re: **Geotechnical Response to Peer Review Comments**
 Proposed High-Rise Building
 1040 Somerset Street West - Ottawa

date: August 12, 2021

file: PG2674-MEMO.09

SK1a

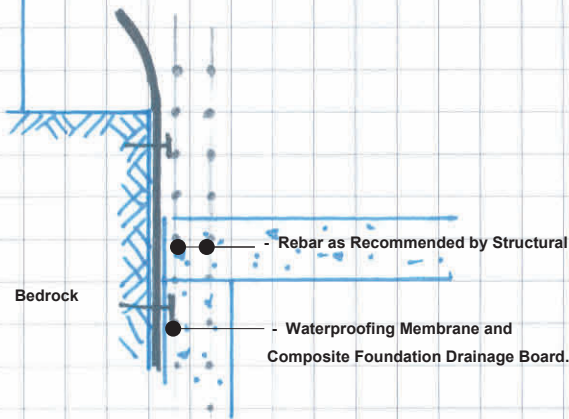
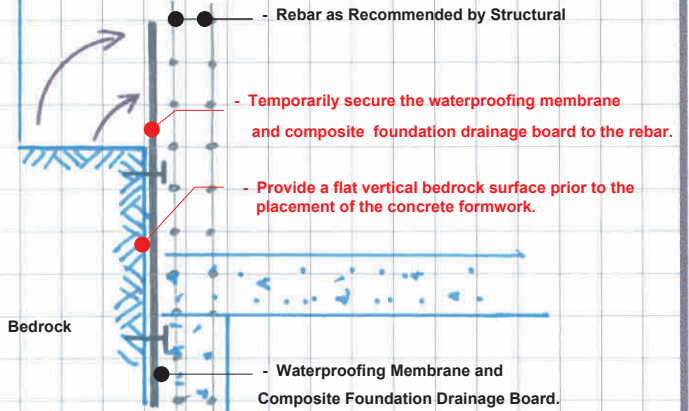
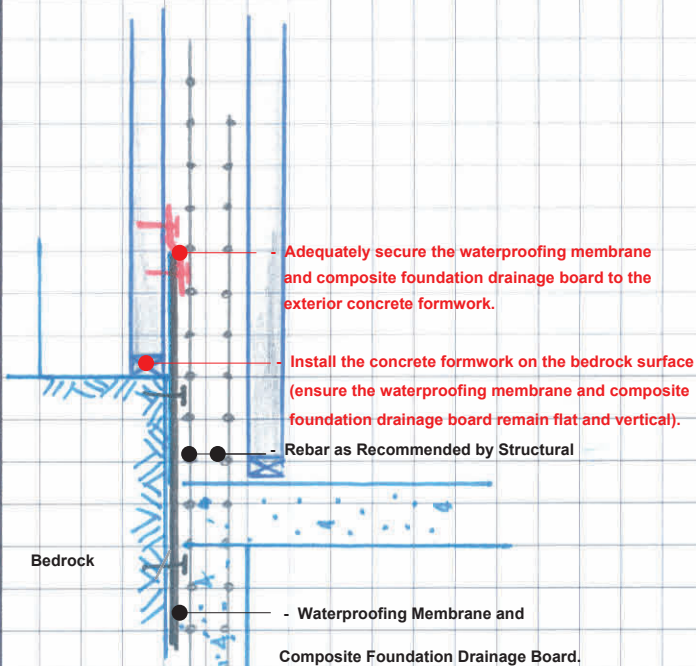
Comment: *Long-term lowering of the groundwater at this Site is a concern. The Geotechnical Investigation requires a bento-mat installed on the rock face to ensure a water-tight bathtub design. This design detail requires significant detailing to address specific areas such as the rock ledge, the shoring and walers, and the tie backs. If the installation and/or detailing is not done properly, this will have long-term settlement effects on surrounding structures due to lowering of the groundwater. As this is a critical item, DST recommends that this installation be inspected and certified by a Quality Verification Engineer (QVE) as part of proposed construction monitoring.*

Response: Waterproofing and foundation drainage details for the bedrock ledge are provided on Sketch SK 1 in Appendix 2 of the updated Geotechnical Investigation Report (Paterson Group Report PG2674-2 Revision 3 dated August 12, 2021) and are also attached following this memo.

Above the bedrock ledge, the temporary shoring system will be setback 1 m from the bedrock face. Therefore, above the bedrock, where the walers and tieback anchors will be located, it is anticipated that the waterproofing and foundation drainage will be installed directly against the exterior of the concrete foundation wall, and not using a blind-side application directly against the temporary shoring system. Therefore, specific detailing of the waterproofing and drainage board installations around walers, tieback anchors, etc. is not applicable.

- Precaution must be taken at the transition zone between the blind side and double sided pour to maintain a relatively flat exterior surface for installation of the waterproofing membrane and composite foundation drainage board.
